From: [REDACTED]
To: [Norfolk Boreas](#)
Subject: Boreas Project EN010087
Date: 05 March 2020 21:39:56
Attachments: [viewpoint3landform2.png](#)
[viewpoint7landform2.png](#)

Viewpoint 3. Scenario1. Landform Cross-Section + Converter Hall, and View Line Positioned In Scale.

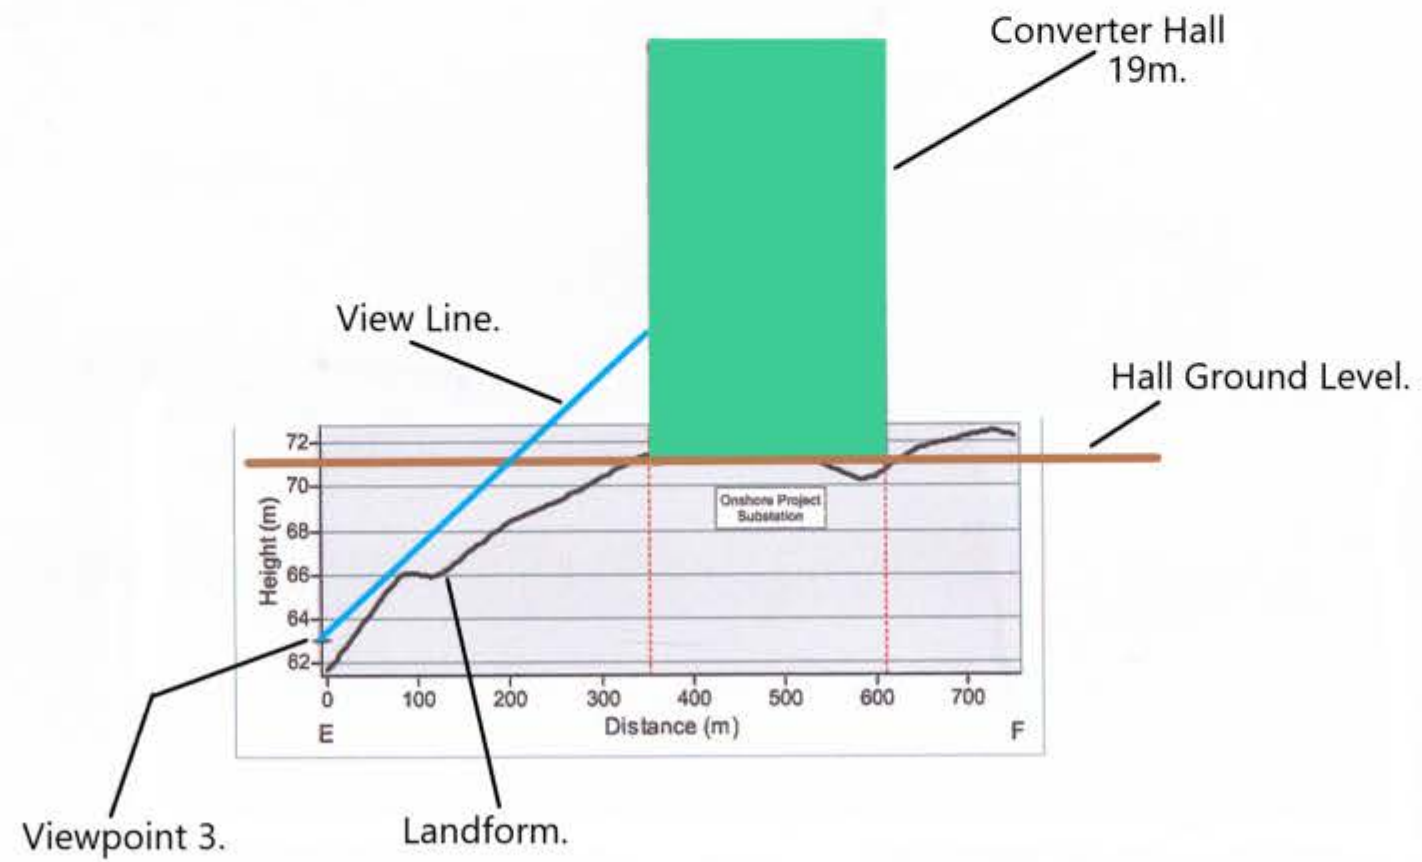
2.9.3.3. I found the cross-sections of the land form provided by the applicant of little use. I have taken the cross-section diagrams and added a 19m converter hall, a level ground, line of view, a viewpoint at 1.5m, and mitigating trees where applicable, using the appropriate scales. This again shows a discrepancy when compared to the photo montages.

After completing the diagrams, which again appeared different to what I expected, I realised they are not drawn to scale. The applicant used one rate of scale for distance, and another for the height. The result is a diagram compressed in length, and overly high. This makes the line of view falsely steep, and the point it intersects the hall unrealistically high. If the diagram had been prepared in scale, it would be much longer, the line of view much shallower, and most of the converter hall would be visible, as I have always suspected. As these cross-sections are another poor tool, it would seem the applicant does not consider mitigating the Necton substation properly, a serious consideration.
